Fwd: REVISED LETTER: 8150 W. Sunset Boulevard Mixed-Use Revised Project - DOT Letter

8150 W. Sunset Bl
DOT Case No. CEN 16-44691

Subject: **UPDATED TRANSPORTATION ANALYSIS FOR THE PROPOSED MIXED-USE PROJECT LOCATED AT 8150 WEST SUNSET BOULEVARD**

CONCEPTUAL INTERSECTION IMPROVEMENTS
SUNSET BOULEVARD AND
CRESCENT HEIGHTS BOULEVARD

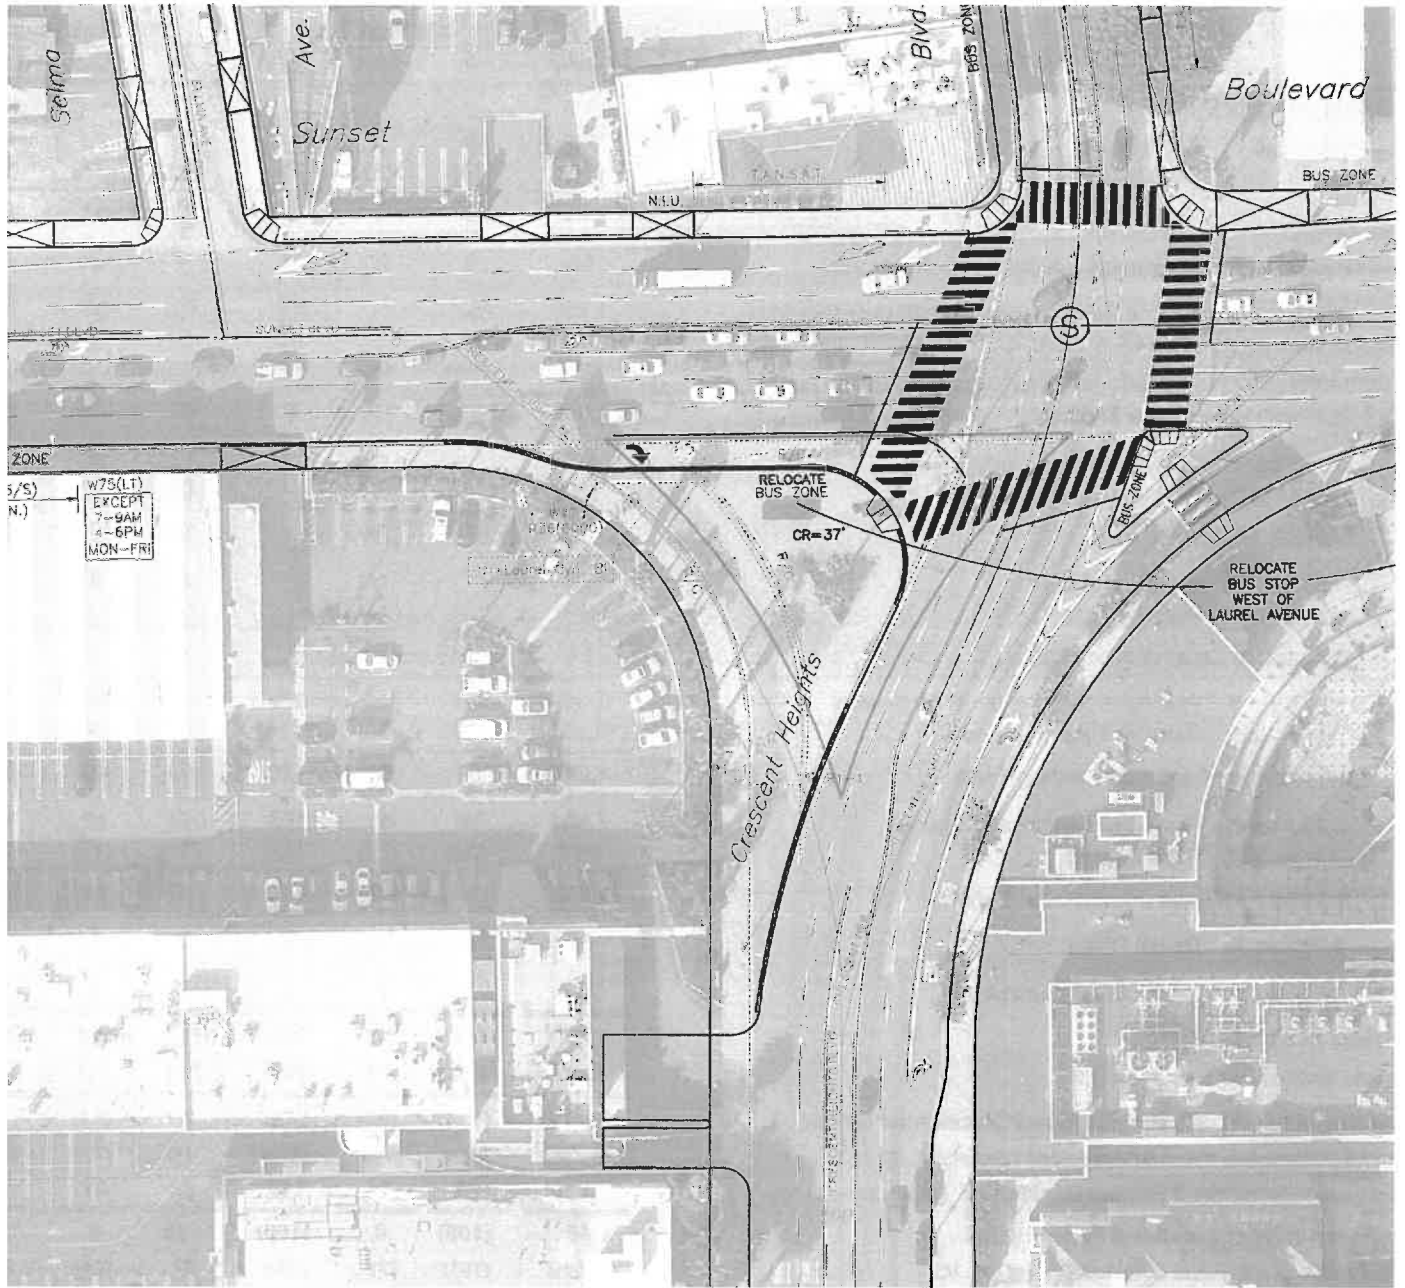
To enhance and activate the pedestrian environment adjacent to the project, the project proposes to reconfigure the southwest quadrant of the intersection of Sunset Boulevard and Crescent Heights Boulevard. The improvement would remove the current sweeping eastbound right-turn lane on Sunset Boulevard that is stop-controlled before merging with southbound Crescent Heights Boulevard, and install a typical exclusive right-turn lane at the intersection. The unused "triangle" section would then be reconfigured to provide a new public "plaza" area adjacent to the northeast corner of the project site as illustrated in **Attachment 3**.

To accommodate the exclusive eastbound right-turn lane, the south side of Sunset Boulevard would be widened and the west side of Crescent Heights Boulevard between Sunset Boulevard and the project's driveway would be reconstructed. Conceptually, this improvement is acceptable to DOT; however, to ensure optimal efficiency and safety of the intersection's operations for all modes, the existing bus stop on the eastbound approach should be relocated from the near-side and the traffic signal may need to be upgraded to install northbound left-turn phasing and concurrent eastbound right-turn phasing (subject to review by DOT's Hollywood/Wilshire District Office). These design issues should be discussed with DOT and Council District 4 prior to the commencement of the engineering plans for this improvement.

This section of Sunset Boulevard has been identified as a roadway within the High Injury Network (HIN), which spotlights streets with a high concentration of traffic collisions that result in severe injuries and deaths, with an emphasis on those involving people walking and bicycling. The proposed improvement would result in enhanced safety by removing the sweeping eastbound right-turn lane, thus eliminating a pedestrian-vehicle conflict point.

8150 SUNSET - ALTERNATIVE 9 PROJECT
PROPOSED PROJECT DRIVEWAY LOCATIONS AND OPERATIONS

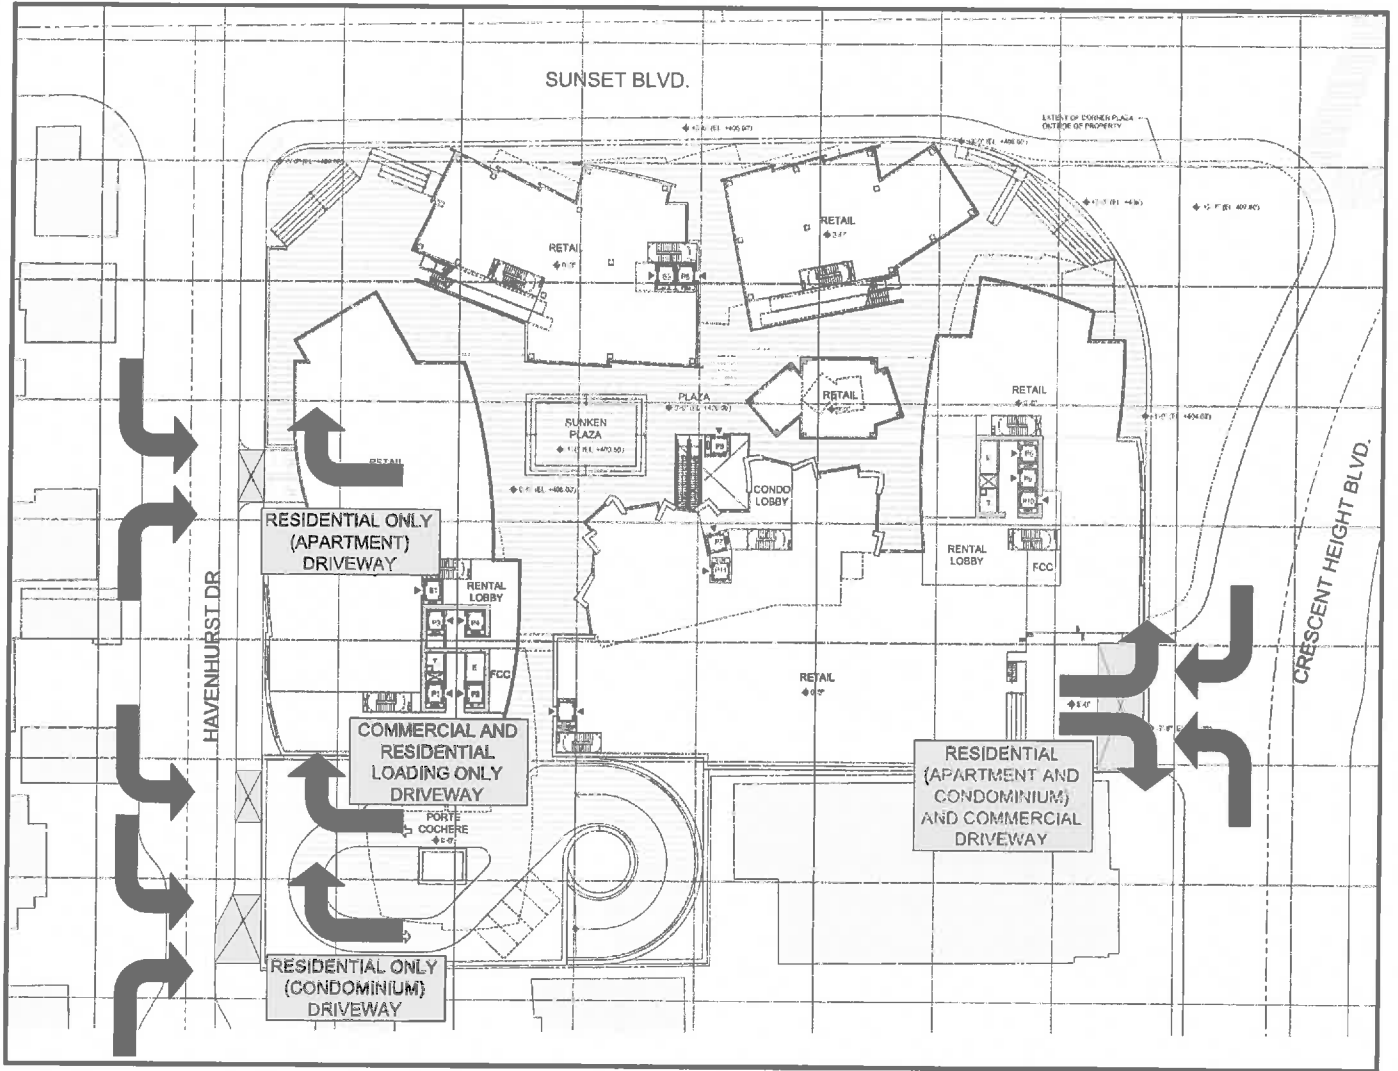
The proposed project will provide vehicular access via three driveways: a driveway on Crescent Heights Boulevard (two-way full access) and two on Havenhurst Drive (both full service entry only driveways and right-turn only exit) as illustrated in **Attachment 4**. If the voluntary intersection improvement is not completed at Crescent Heights Boulevard and Sunset Boulevard, then driveway on Crescent Heights Boulevard should be restricted to right-turn ingress/egress only. The analysis studied this scenario and it did not change the results. Truck access to the on-site loading dock facilities is provided on Havenhurst Drive. The project also proposes a passenger pick-up/drop-off loading area onsite via the project driveways.

Review of the study does not constitute approval of the driveway dimensions and internal circulation schemes. Those require separate review and approval and should be coordinated with DOT's Citywide Planning Coordination Section (201 N. Figueroa Street, 4th Floor, Station 3, @ 213-482-7024). In order to minimize potential building design changes, the applicant should contact DOT for driveway width and internal circulation requirements so that such traffic flow considerations

are designed and incorporated early into the building and parking layout plans. All new driveways should be Case 2 driveways and any security gates should be a minimum 20 feet from the property line. All truck loading and unloading should take place on site with no vehicles backing into the project via any of the project driveways.
